From: [REDACTED]
Sent: 25 April 2018 16:13
To: Planning
Cc: [REDACTED] Cllr. Paul Bicknell; Cllr. Andy Cooper; Cllr. Dudley Wensley
Subject: A/38/18/RES Manor Nursery, Angmering

Please find attached Objection to planning application
A/38/18/RES Manor Nursery, Angmering.

Whilst accepting the principal of development on the Manor Nursery site, SAV strongly **OBJECTS** to elements of this application. Specifically, in respect of the proposed main access route to the development via the High Street. The issues highlighted below have already been noted in the previous application A/51/14/OUT for this site, but in our view, have been ignored by the developer.

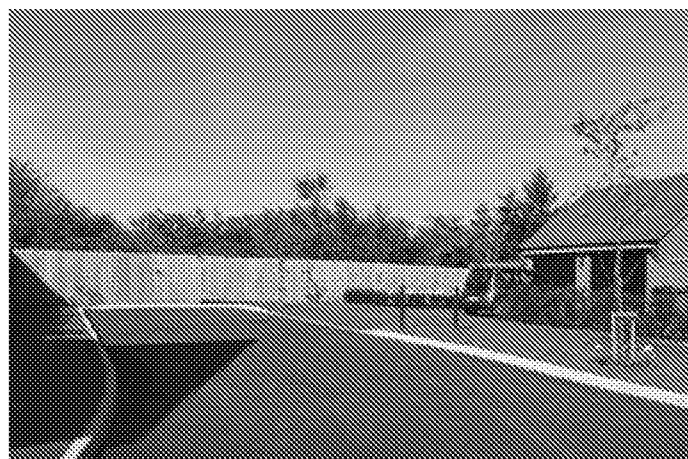
The introduction of footpaths between 1000mm and 1500mm wide are of specific concern relating to the safety of pedestrians and other types of non-motorised users when considering the current use of this rural lane.

Inadequate Footways and footpaths: The latest plan provides additional detail on the widths of the proposed footpaths along High Street which clearly do not provide satisfactory standards of access for all users.

The applicant does not explain or give any reasons why the width of the proposed footpaths along the High Street are significantly less than that recommended by national guidelines, especially when you take into account that in most cases they are bounded on one side by walls or hedgerows, not verges which provide users with additional "elbow room".

Swanbourne Park - Approved Plans (A/82/12) showing "future" access road

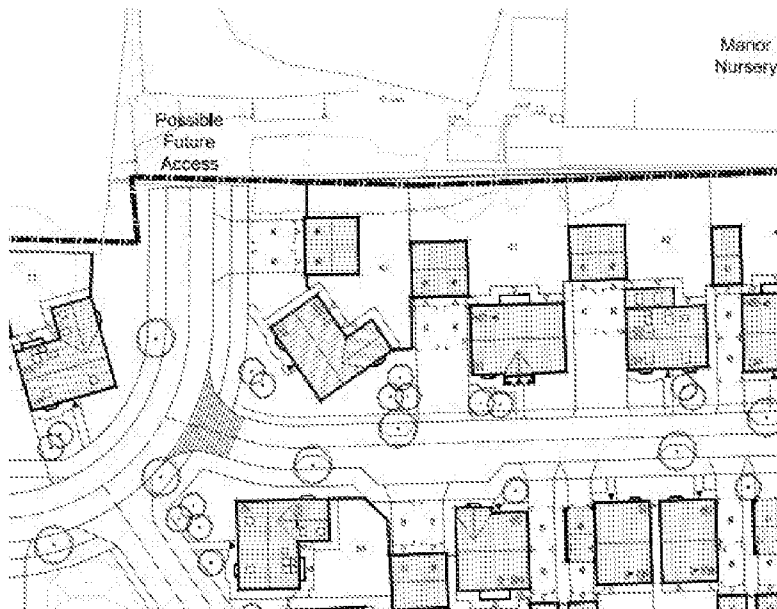
Nanson's Lane on the Swanbourne Park development is a much more suitable route. It is specifically designed as the main access route to the Manor Nursery site, without compromising the amenity role the High Street currently plays or the safety of its non-motorised users as access to the SDNP.

There's absolutely nothing stopping the developer linking the sites (Swanbourne Park and Manor Nursery) using the existing Nanson's Lane access with limited

modifications to the Manor Nursery site layout. Indeed, the applicant's site layout confirms that Nanson's Lane will be used as a non-motorised user access to Roundstone Lane via the Swanbourne Park development, however, at a cost to the existing users and residents of the High Street.
